Service Letter No. 129

October 28, 1949

SUBJECT: Inspection of Landing Gear Shock Strut End Fittings

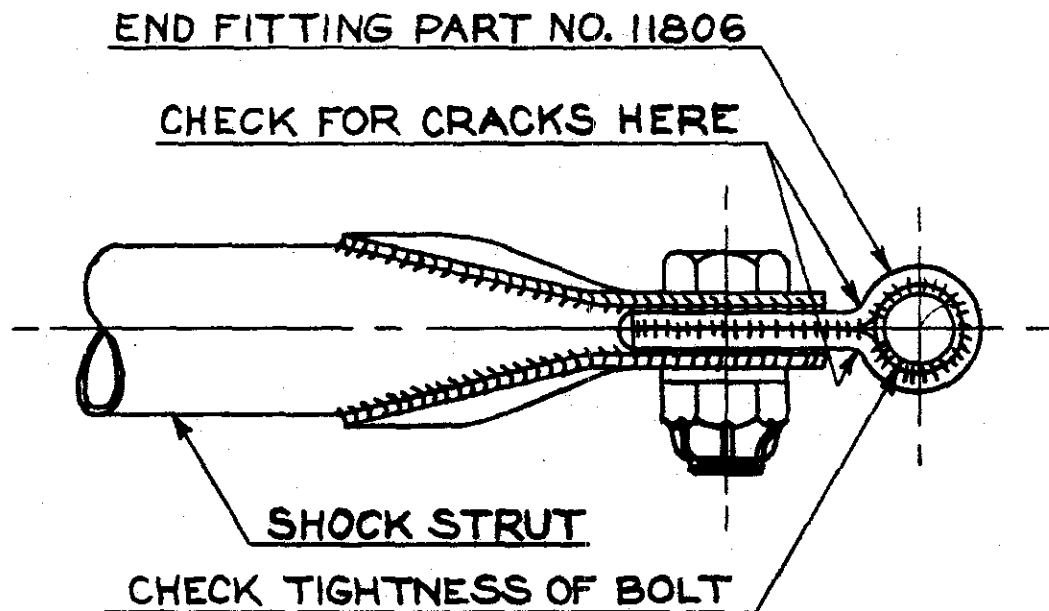
It is recommended that the upper and lower shock strut end fitting attachment bolts be inspected for excessive tightness.

The end fittings (Part No. 11806 - four per airplane) should be sufficiently loose to allow the bolt to turn freely with a 5" end wrench.

Examine the end fittings for possible cracks in the small bend radius, caused by extreme tightening of the attachment bolts.
